## HITACHI SEMICONDUCTOR TECHNICAL UPDATE

Classification of Production	MPU		No	TN-SH7-433A/E	Rev	1
THEME	SH7616 limitation of Ethernet Controller Half-duplex transfer.		Classification of Information	1. Spec change 2. Supplement of Documents ③ Limitation of Use 4. Change of Mask 5. Change of Production Line		
PRODUCT NAME	HD6417616RF	Lot No.	Reference Documents	SH7616 Hardware Manual ADE-602-243 Rev.1.0	Effective Date	
		ALL			Permanent

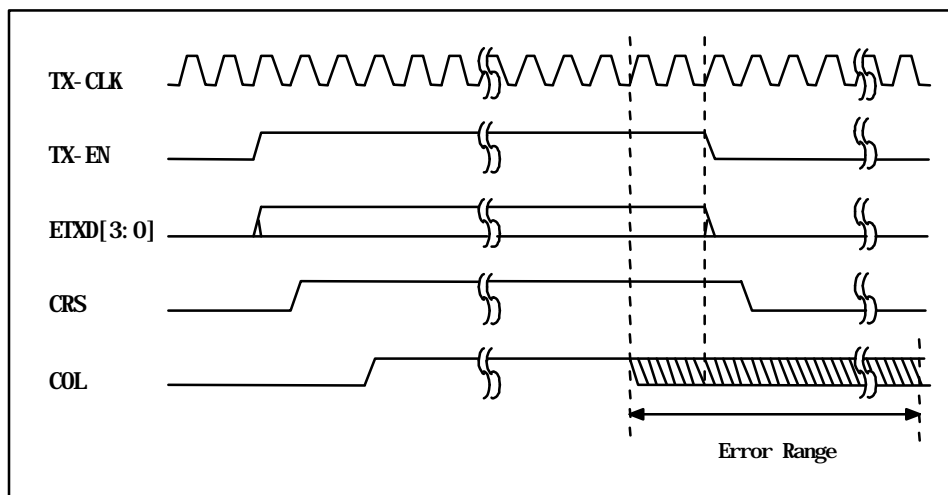
On operating in Half-duplex transfer mode, there is a case that the SH7616 would transmit a frame with jam, even though any Collision doesn't occur. And it would move into the re-transmission state with back-off algorithm.

When the following both conditions are met, the SH7616 would transmit a frame with jam as the next re-try frame and move into back-off, even though any collision doesn't occur at the next re-try.

- (1) SH7616 is in Half-duplex transfer mode.
- (2) SH7616 detects a collision, in which the COL from the PHY gets inactive later than 2 TX-CLKs before TX-EN inactive (refer to the figure below).

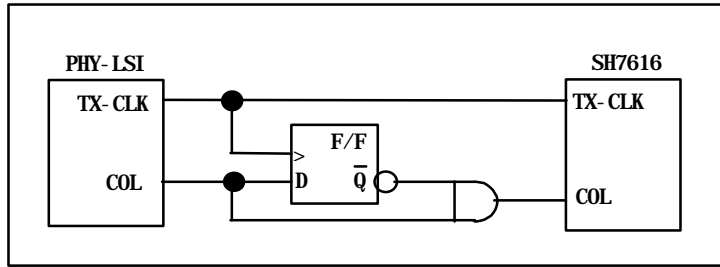
This problem is avoided by adding the following external logic.

- (1) The logic generates one-shot pulse of COL output signal from PHY-LSI.
